November 20, 2023

ADDENDUM #1

Owen Valley Middle School Addition and Interior Renovations

DRAWN BY:	DESIGNED BY:
AWM	GPB
CHECKED BY:	DATE:
GPB	05/02/23
SCALE:	AS NOTED
PROJECT NUMBER:	22286A
SHEET NO.:	A13
	24 of 58

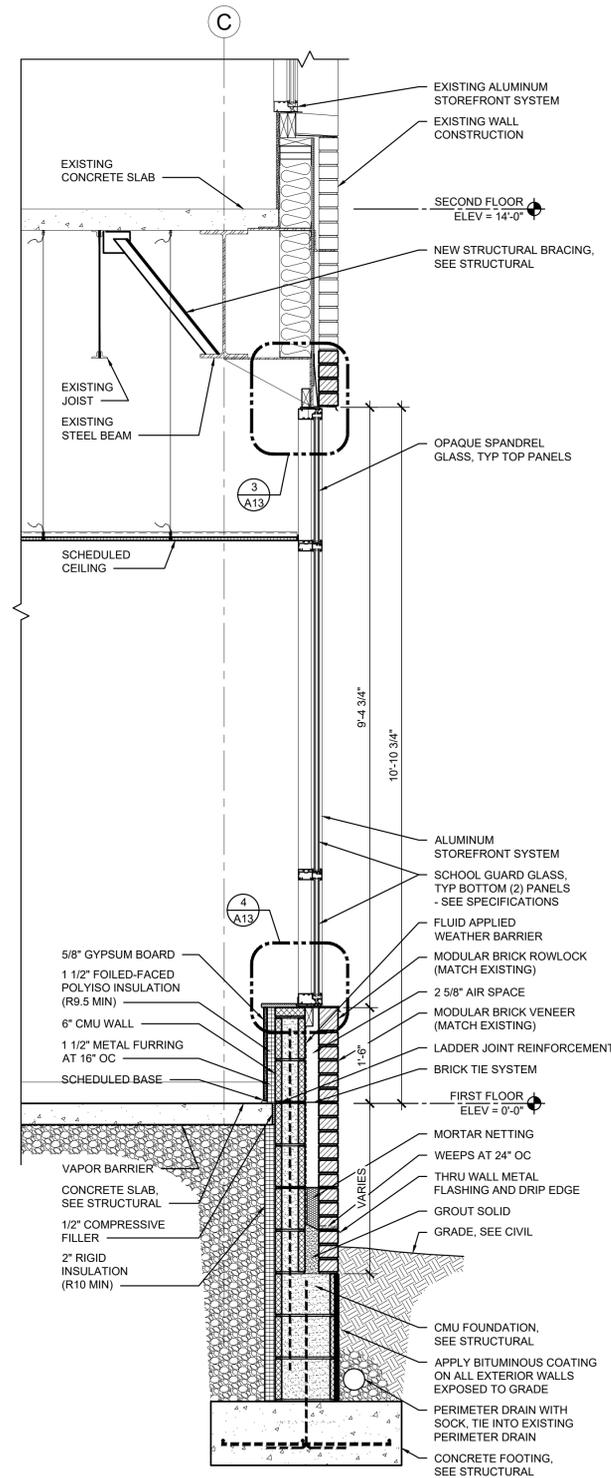
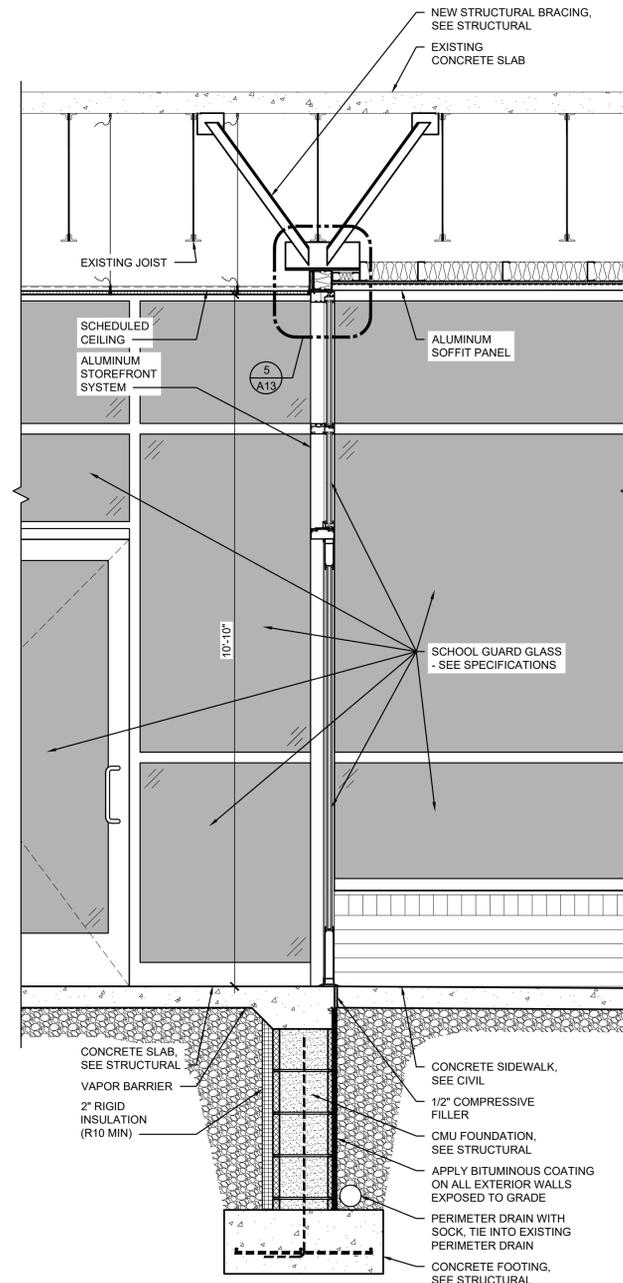
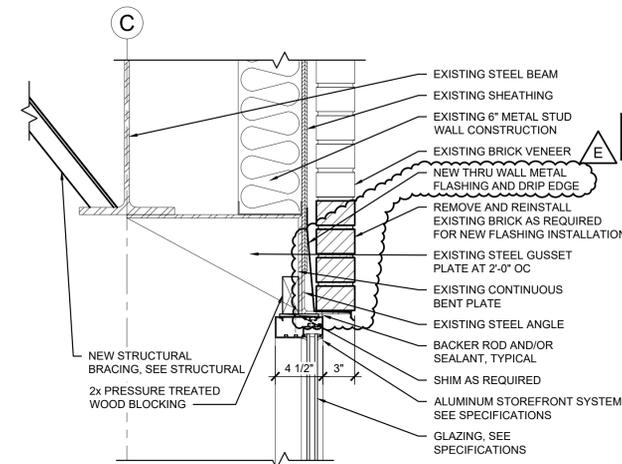
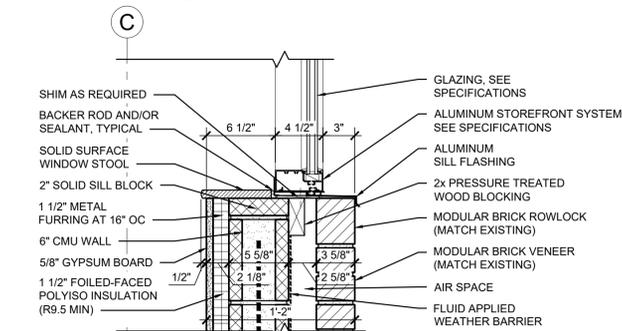
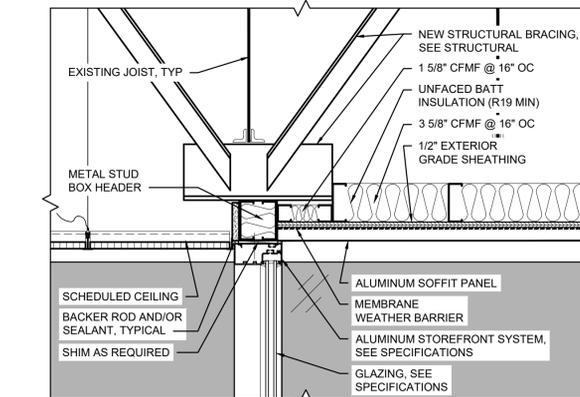
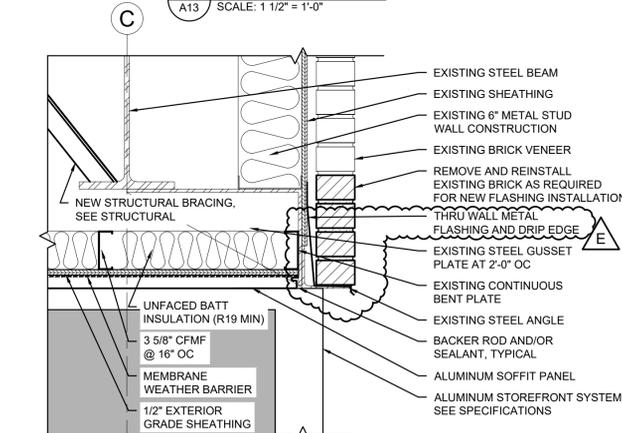
Sheet A13 - Note added for drip edge flashing at the bottom of the masonry opening.
Sheet A15 - Hardware sets revised.

SHEET NO:
P4

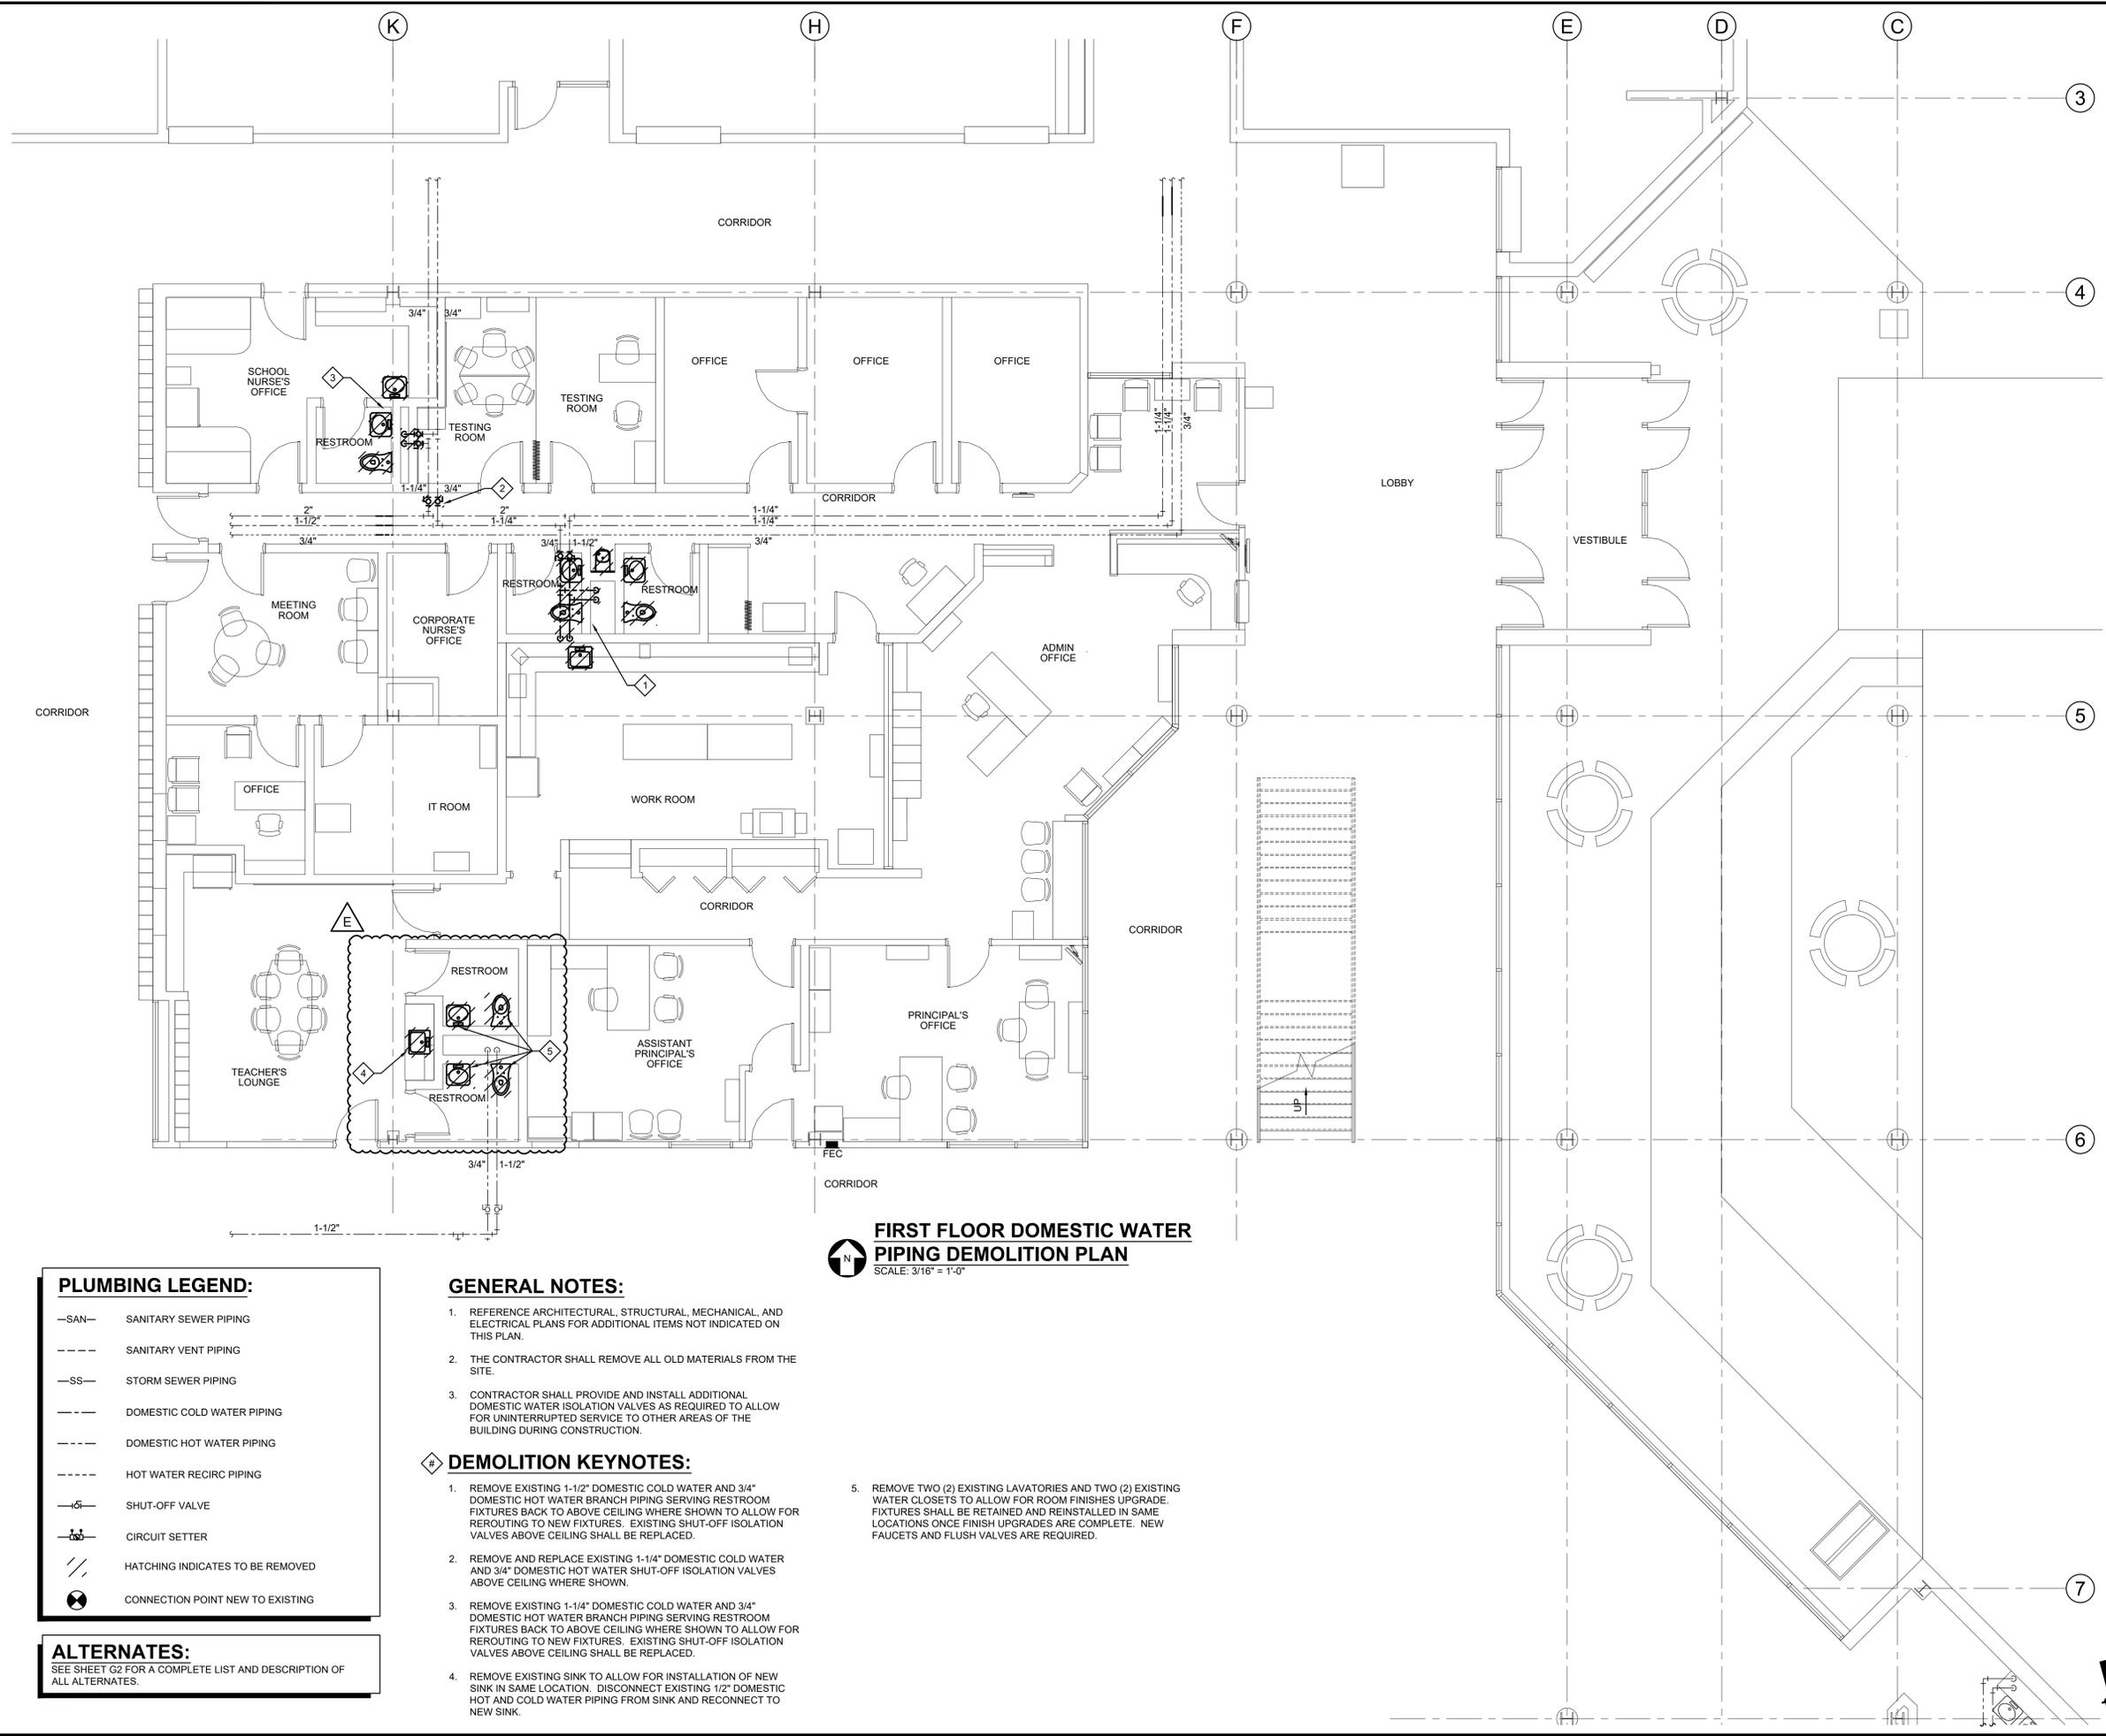
Sheet P4 - Notes reworked at relocated fixtures for better clarity.

SHEET NO: **E3**
52 of 58

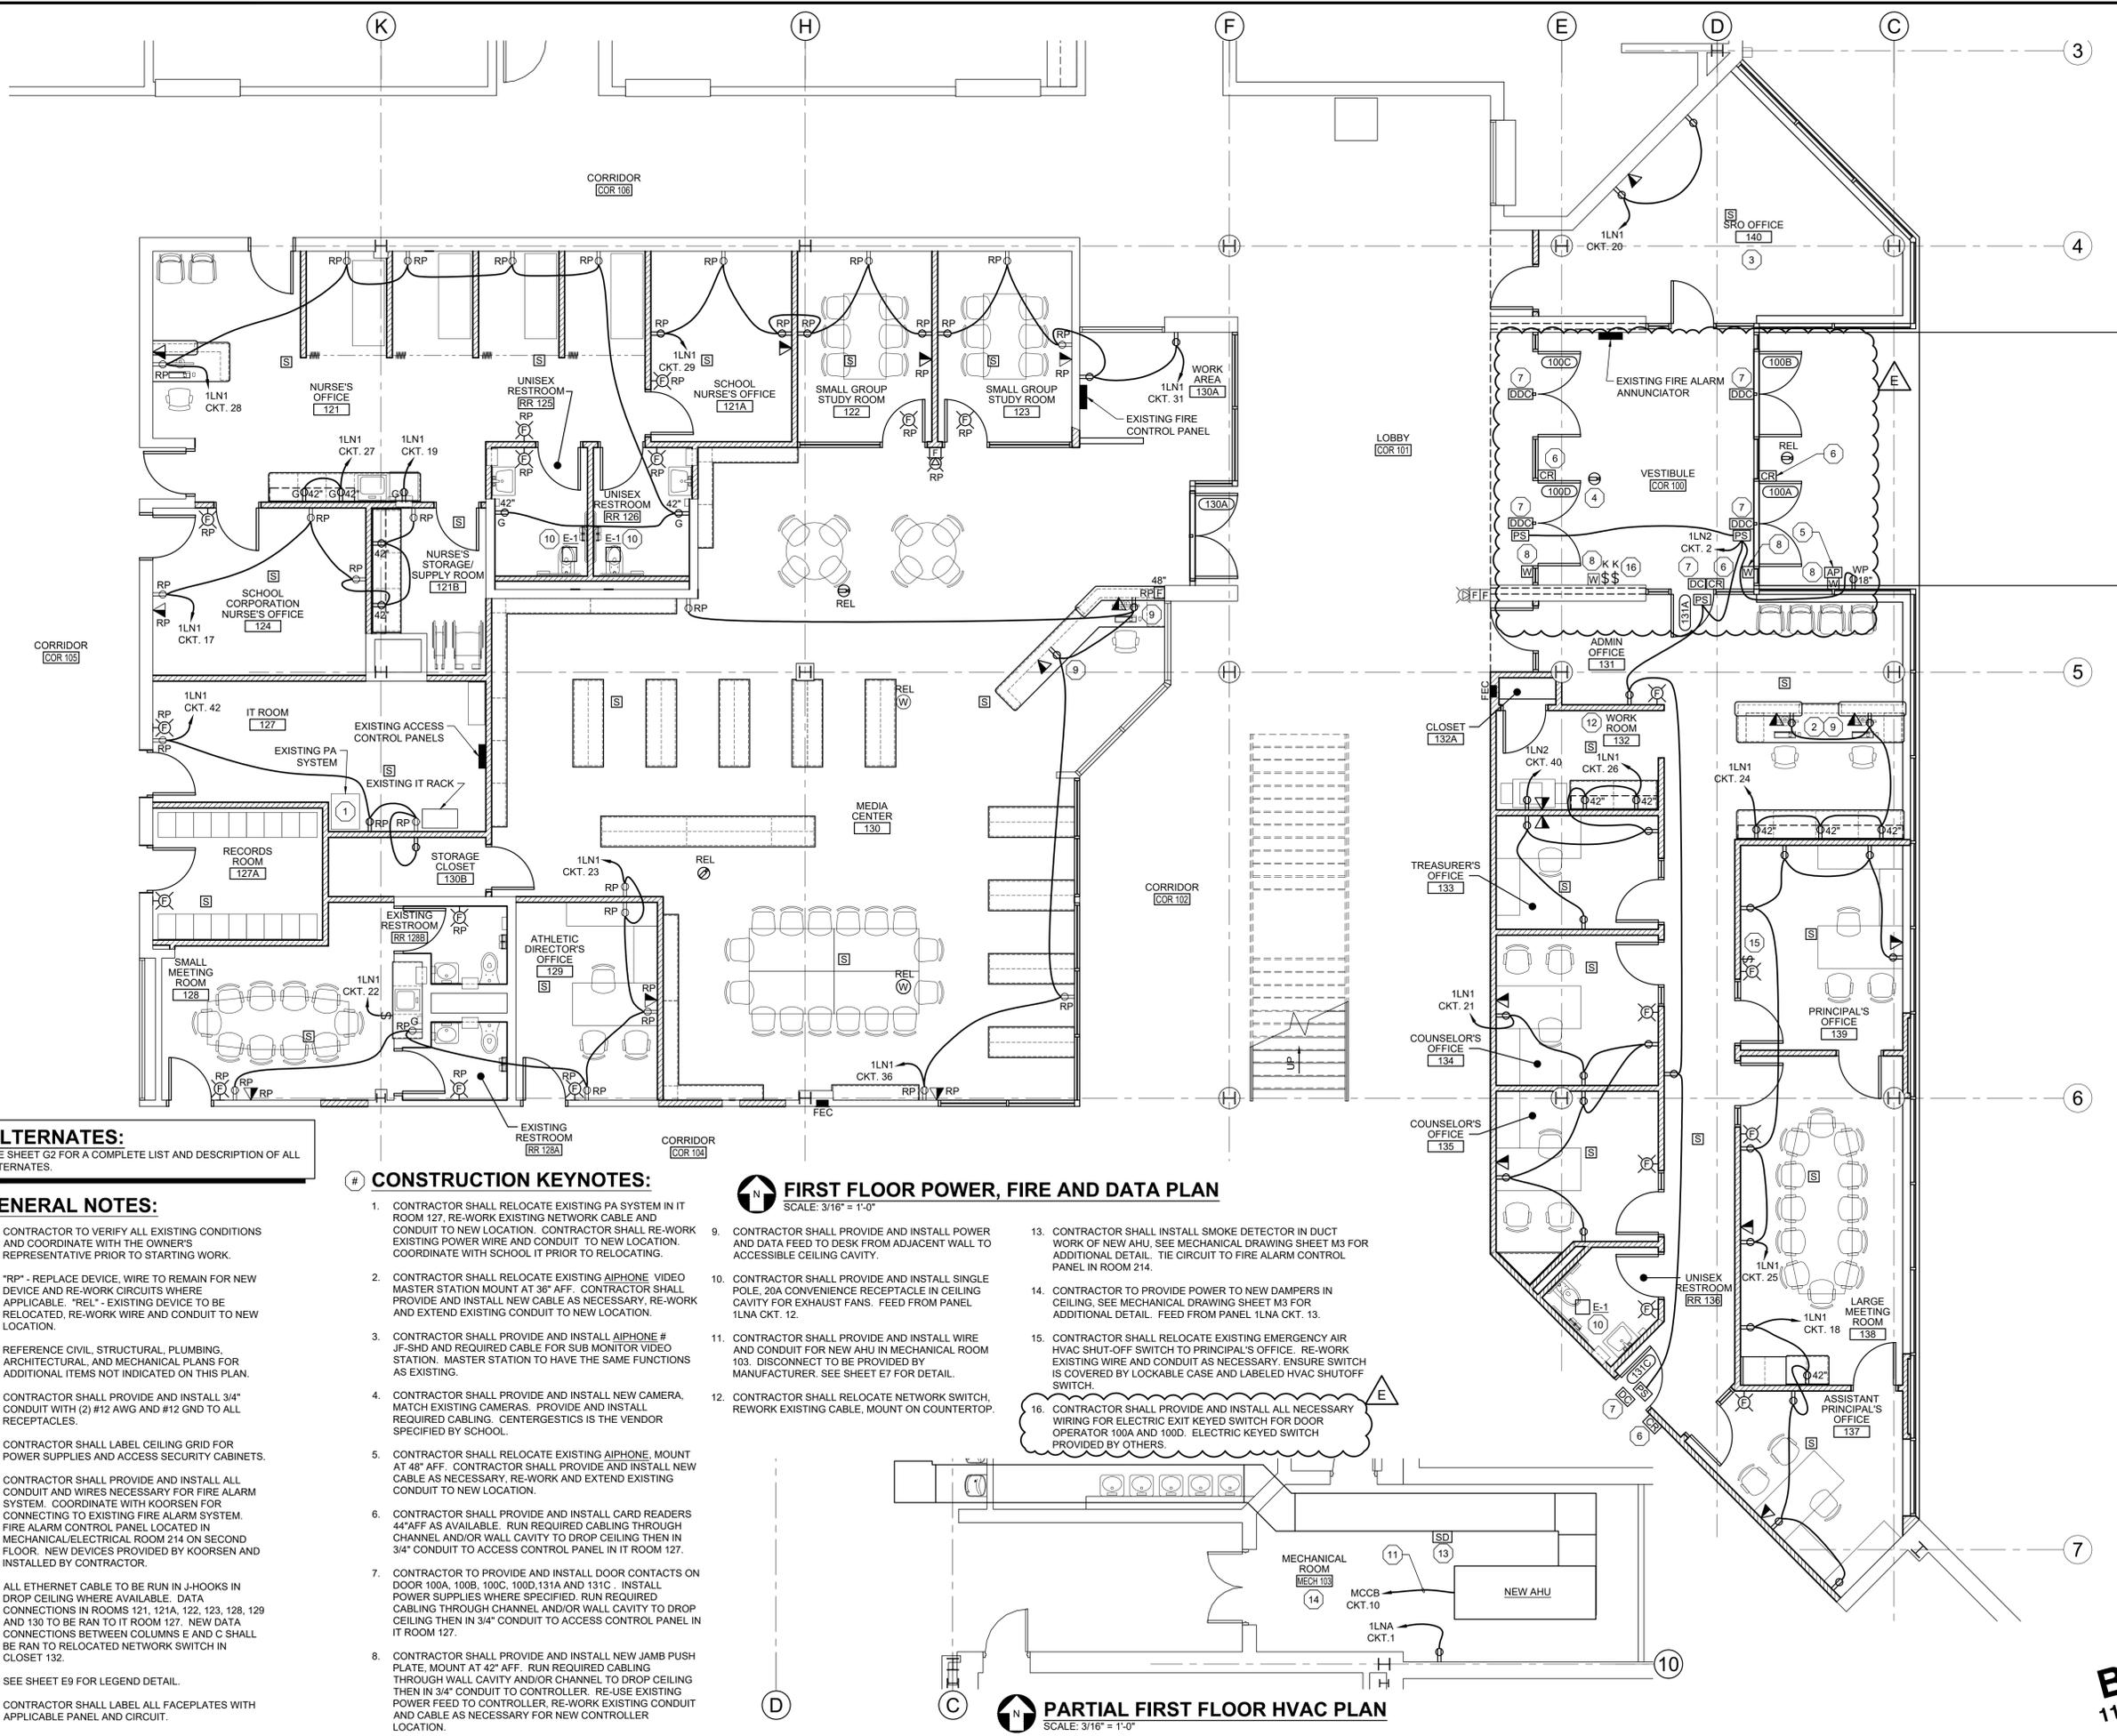
Sheet E3 - Remote switches added to plan to match door hardware schedules.
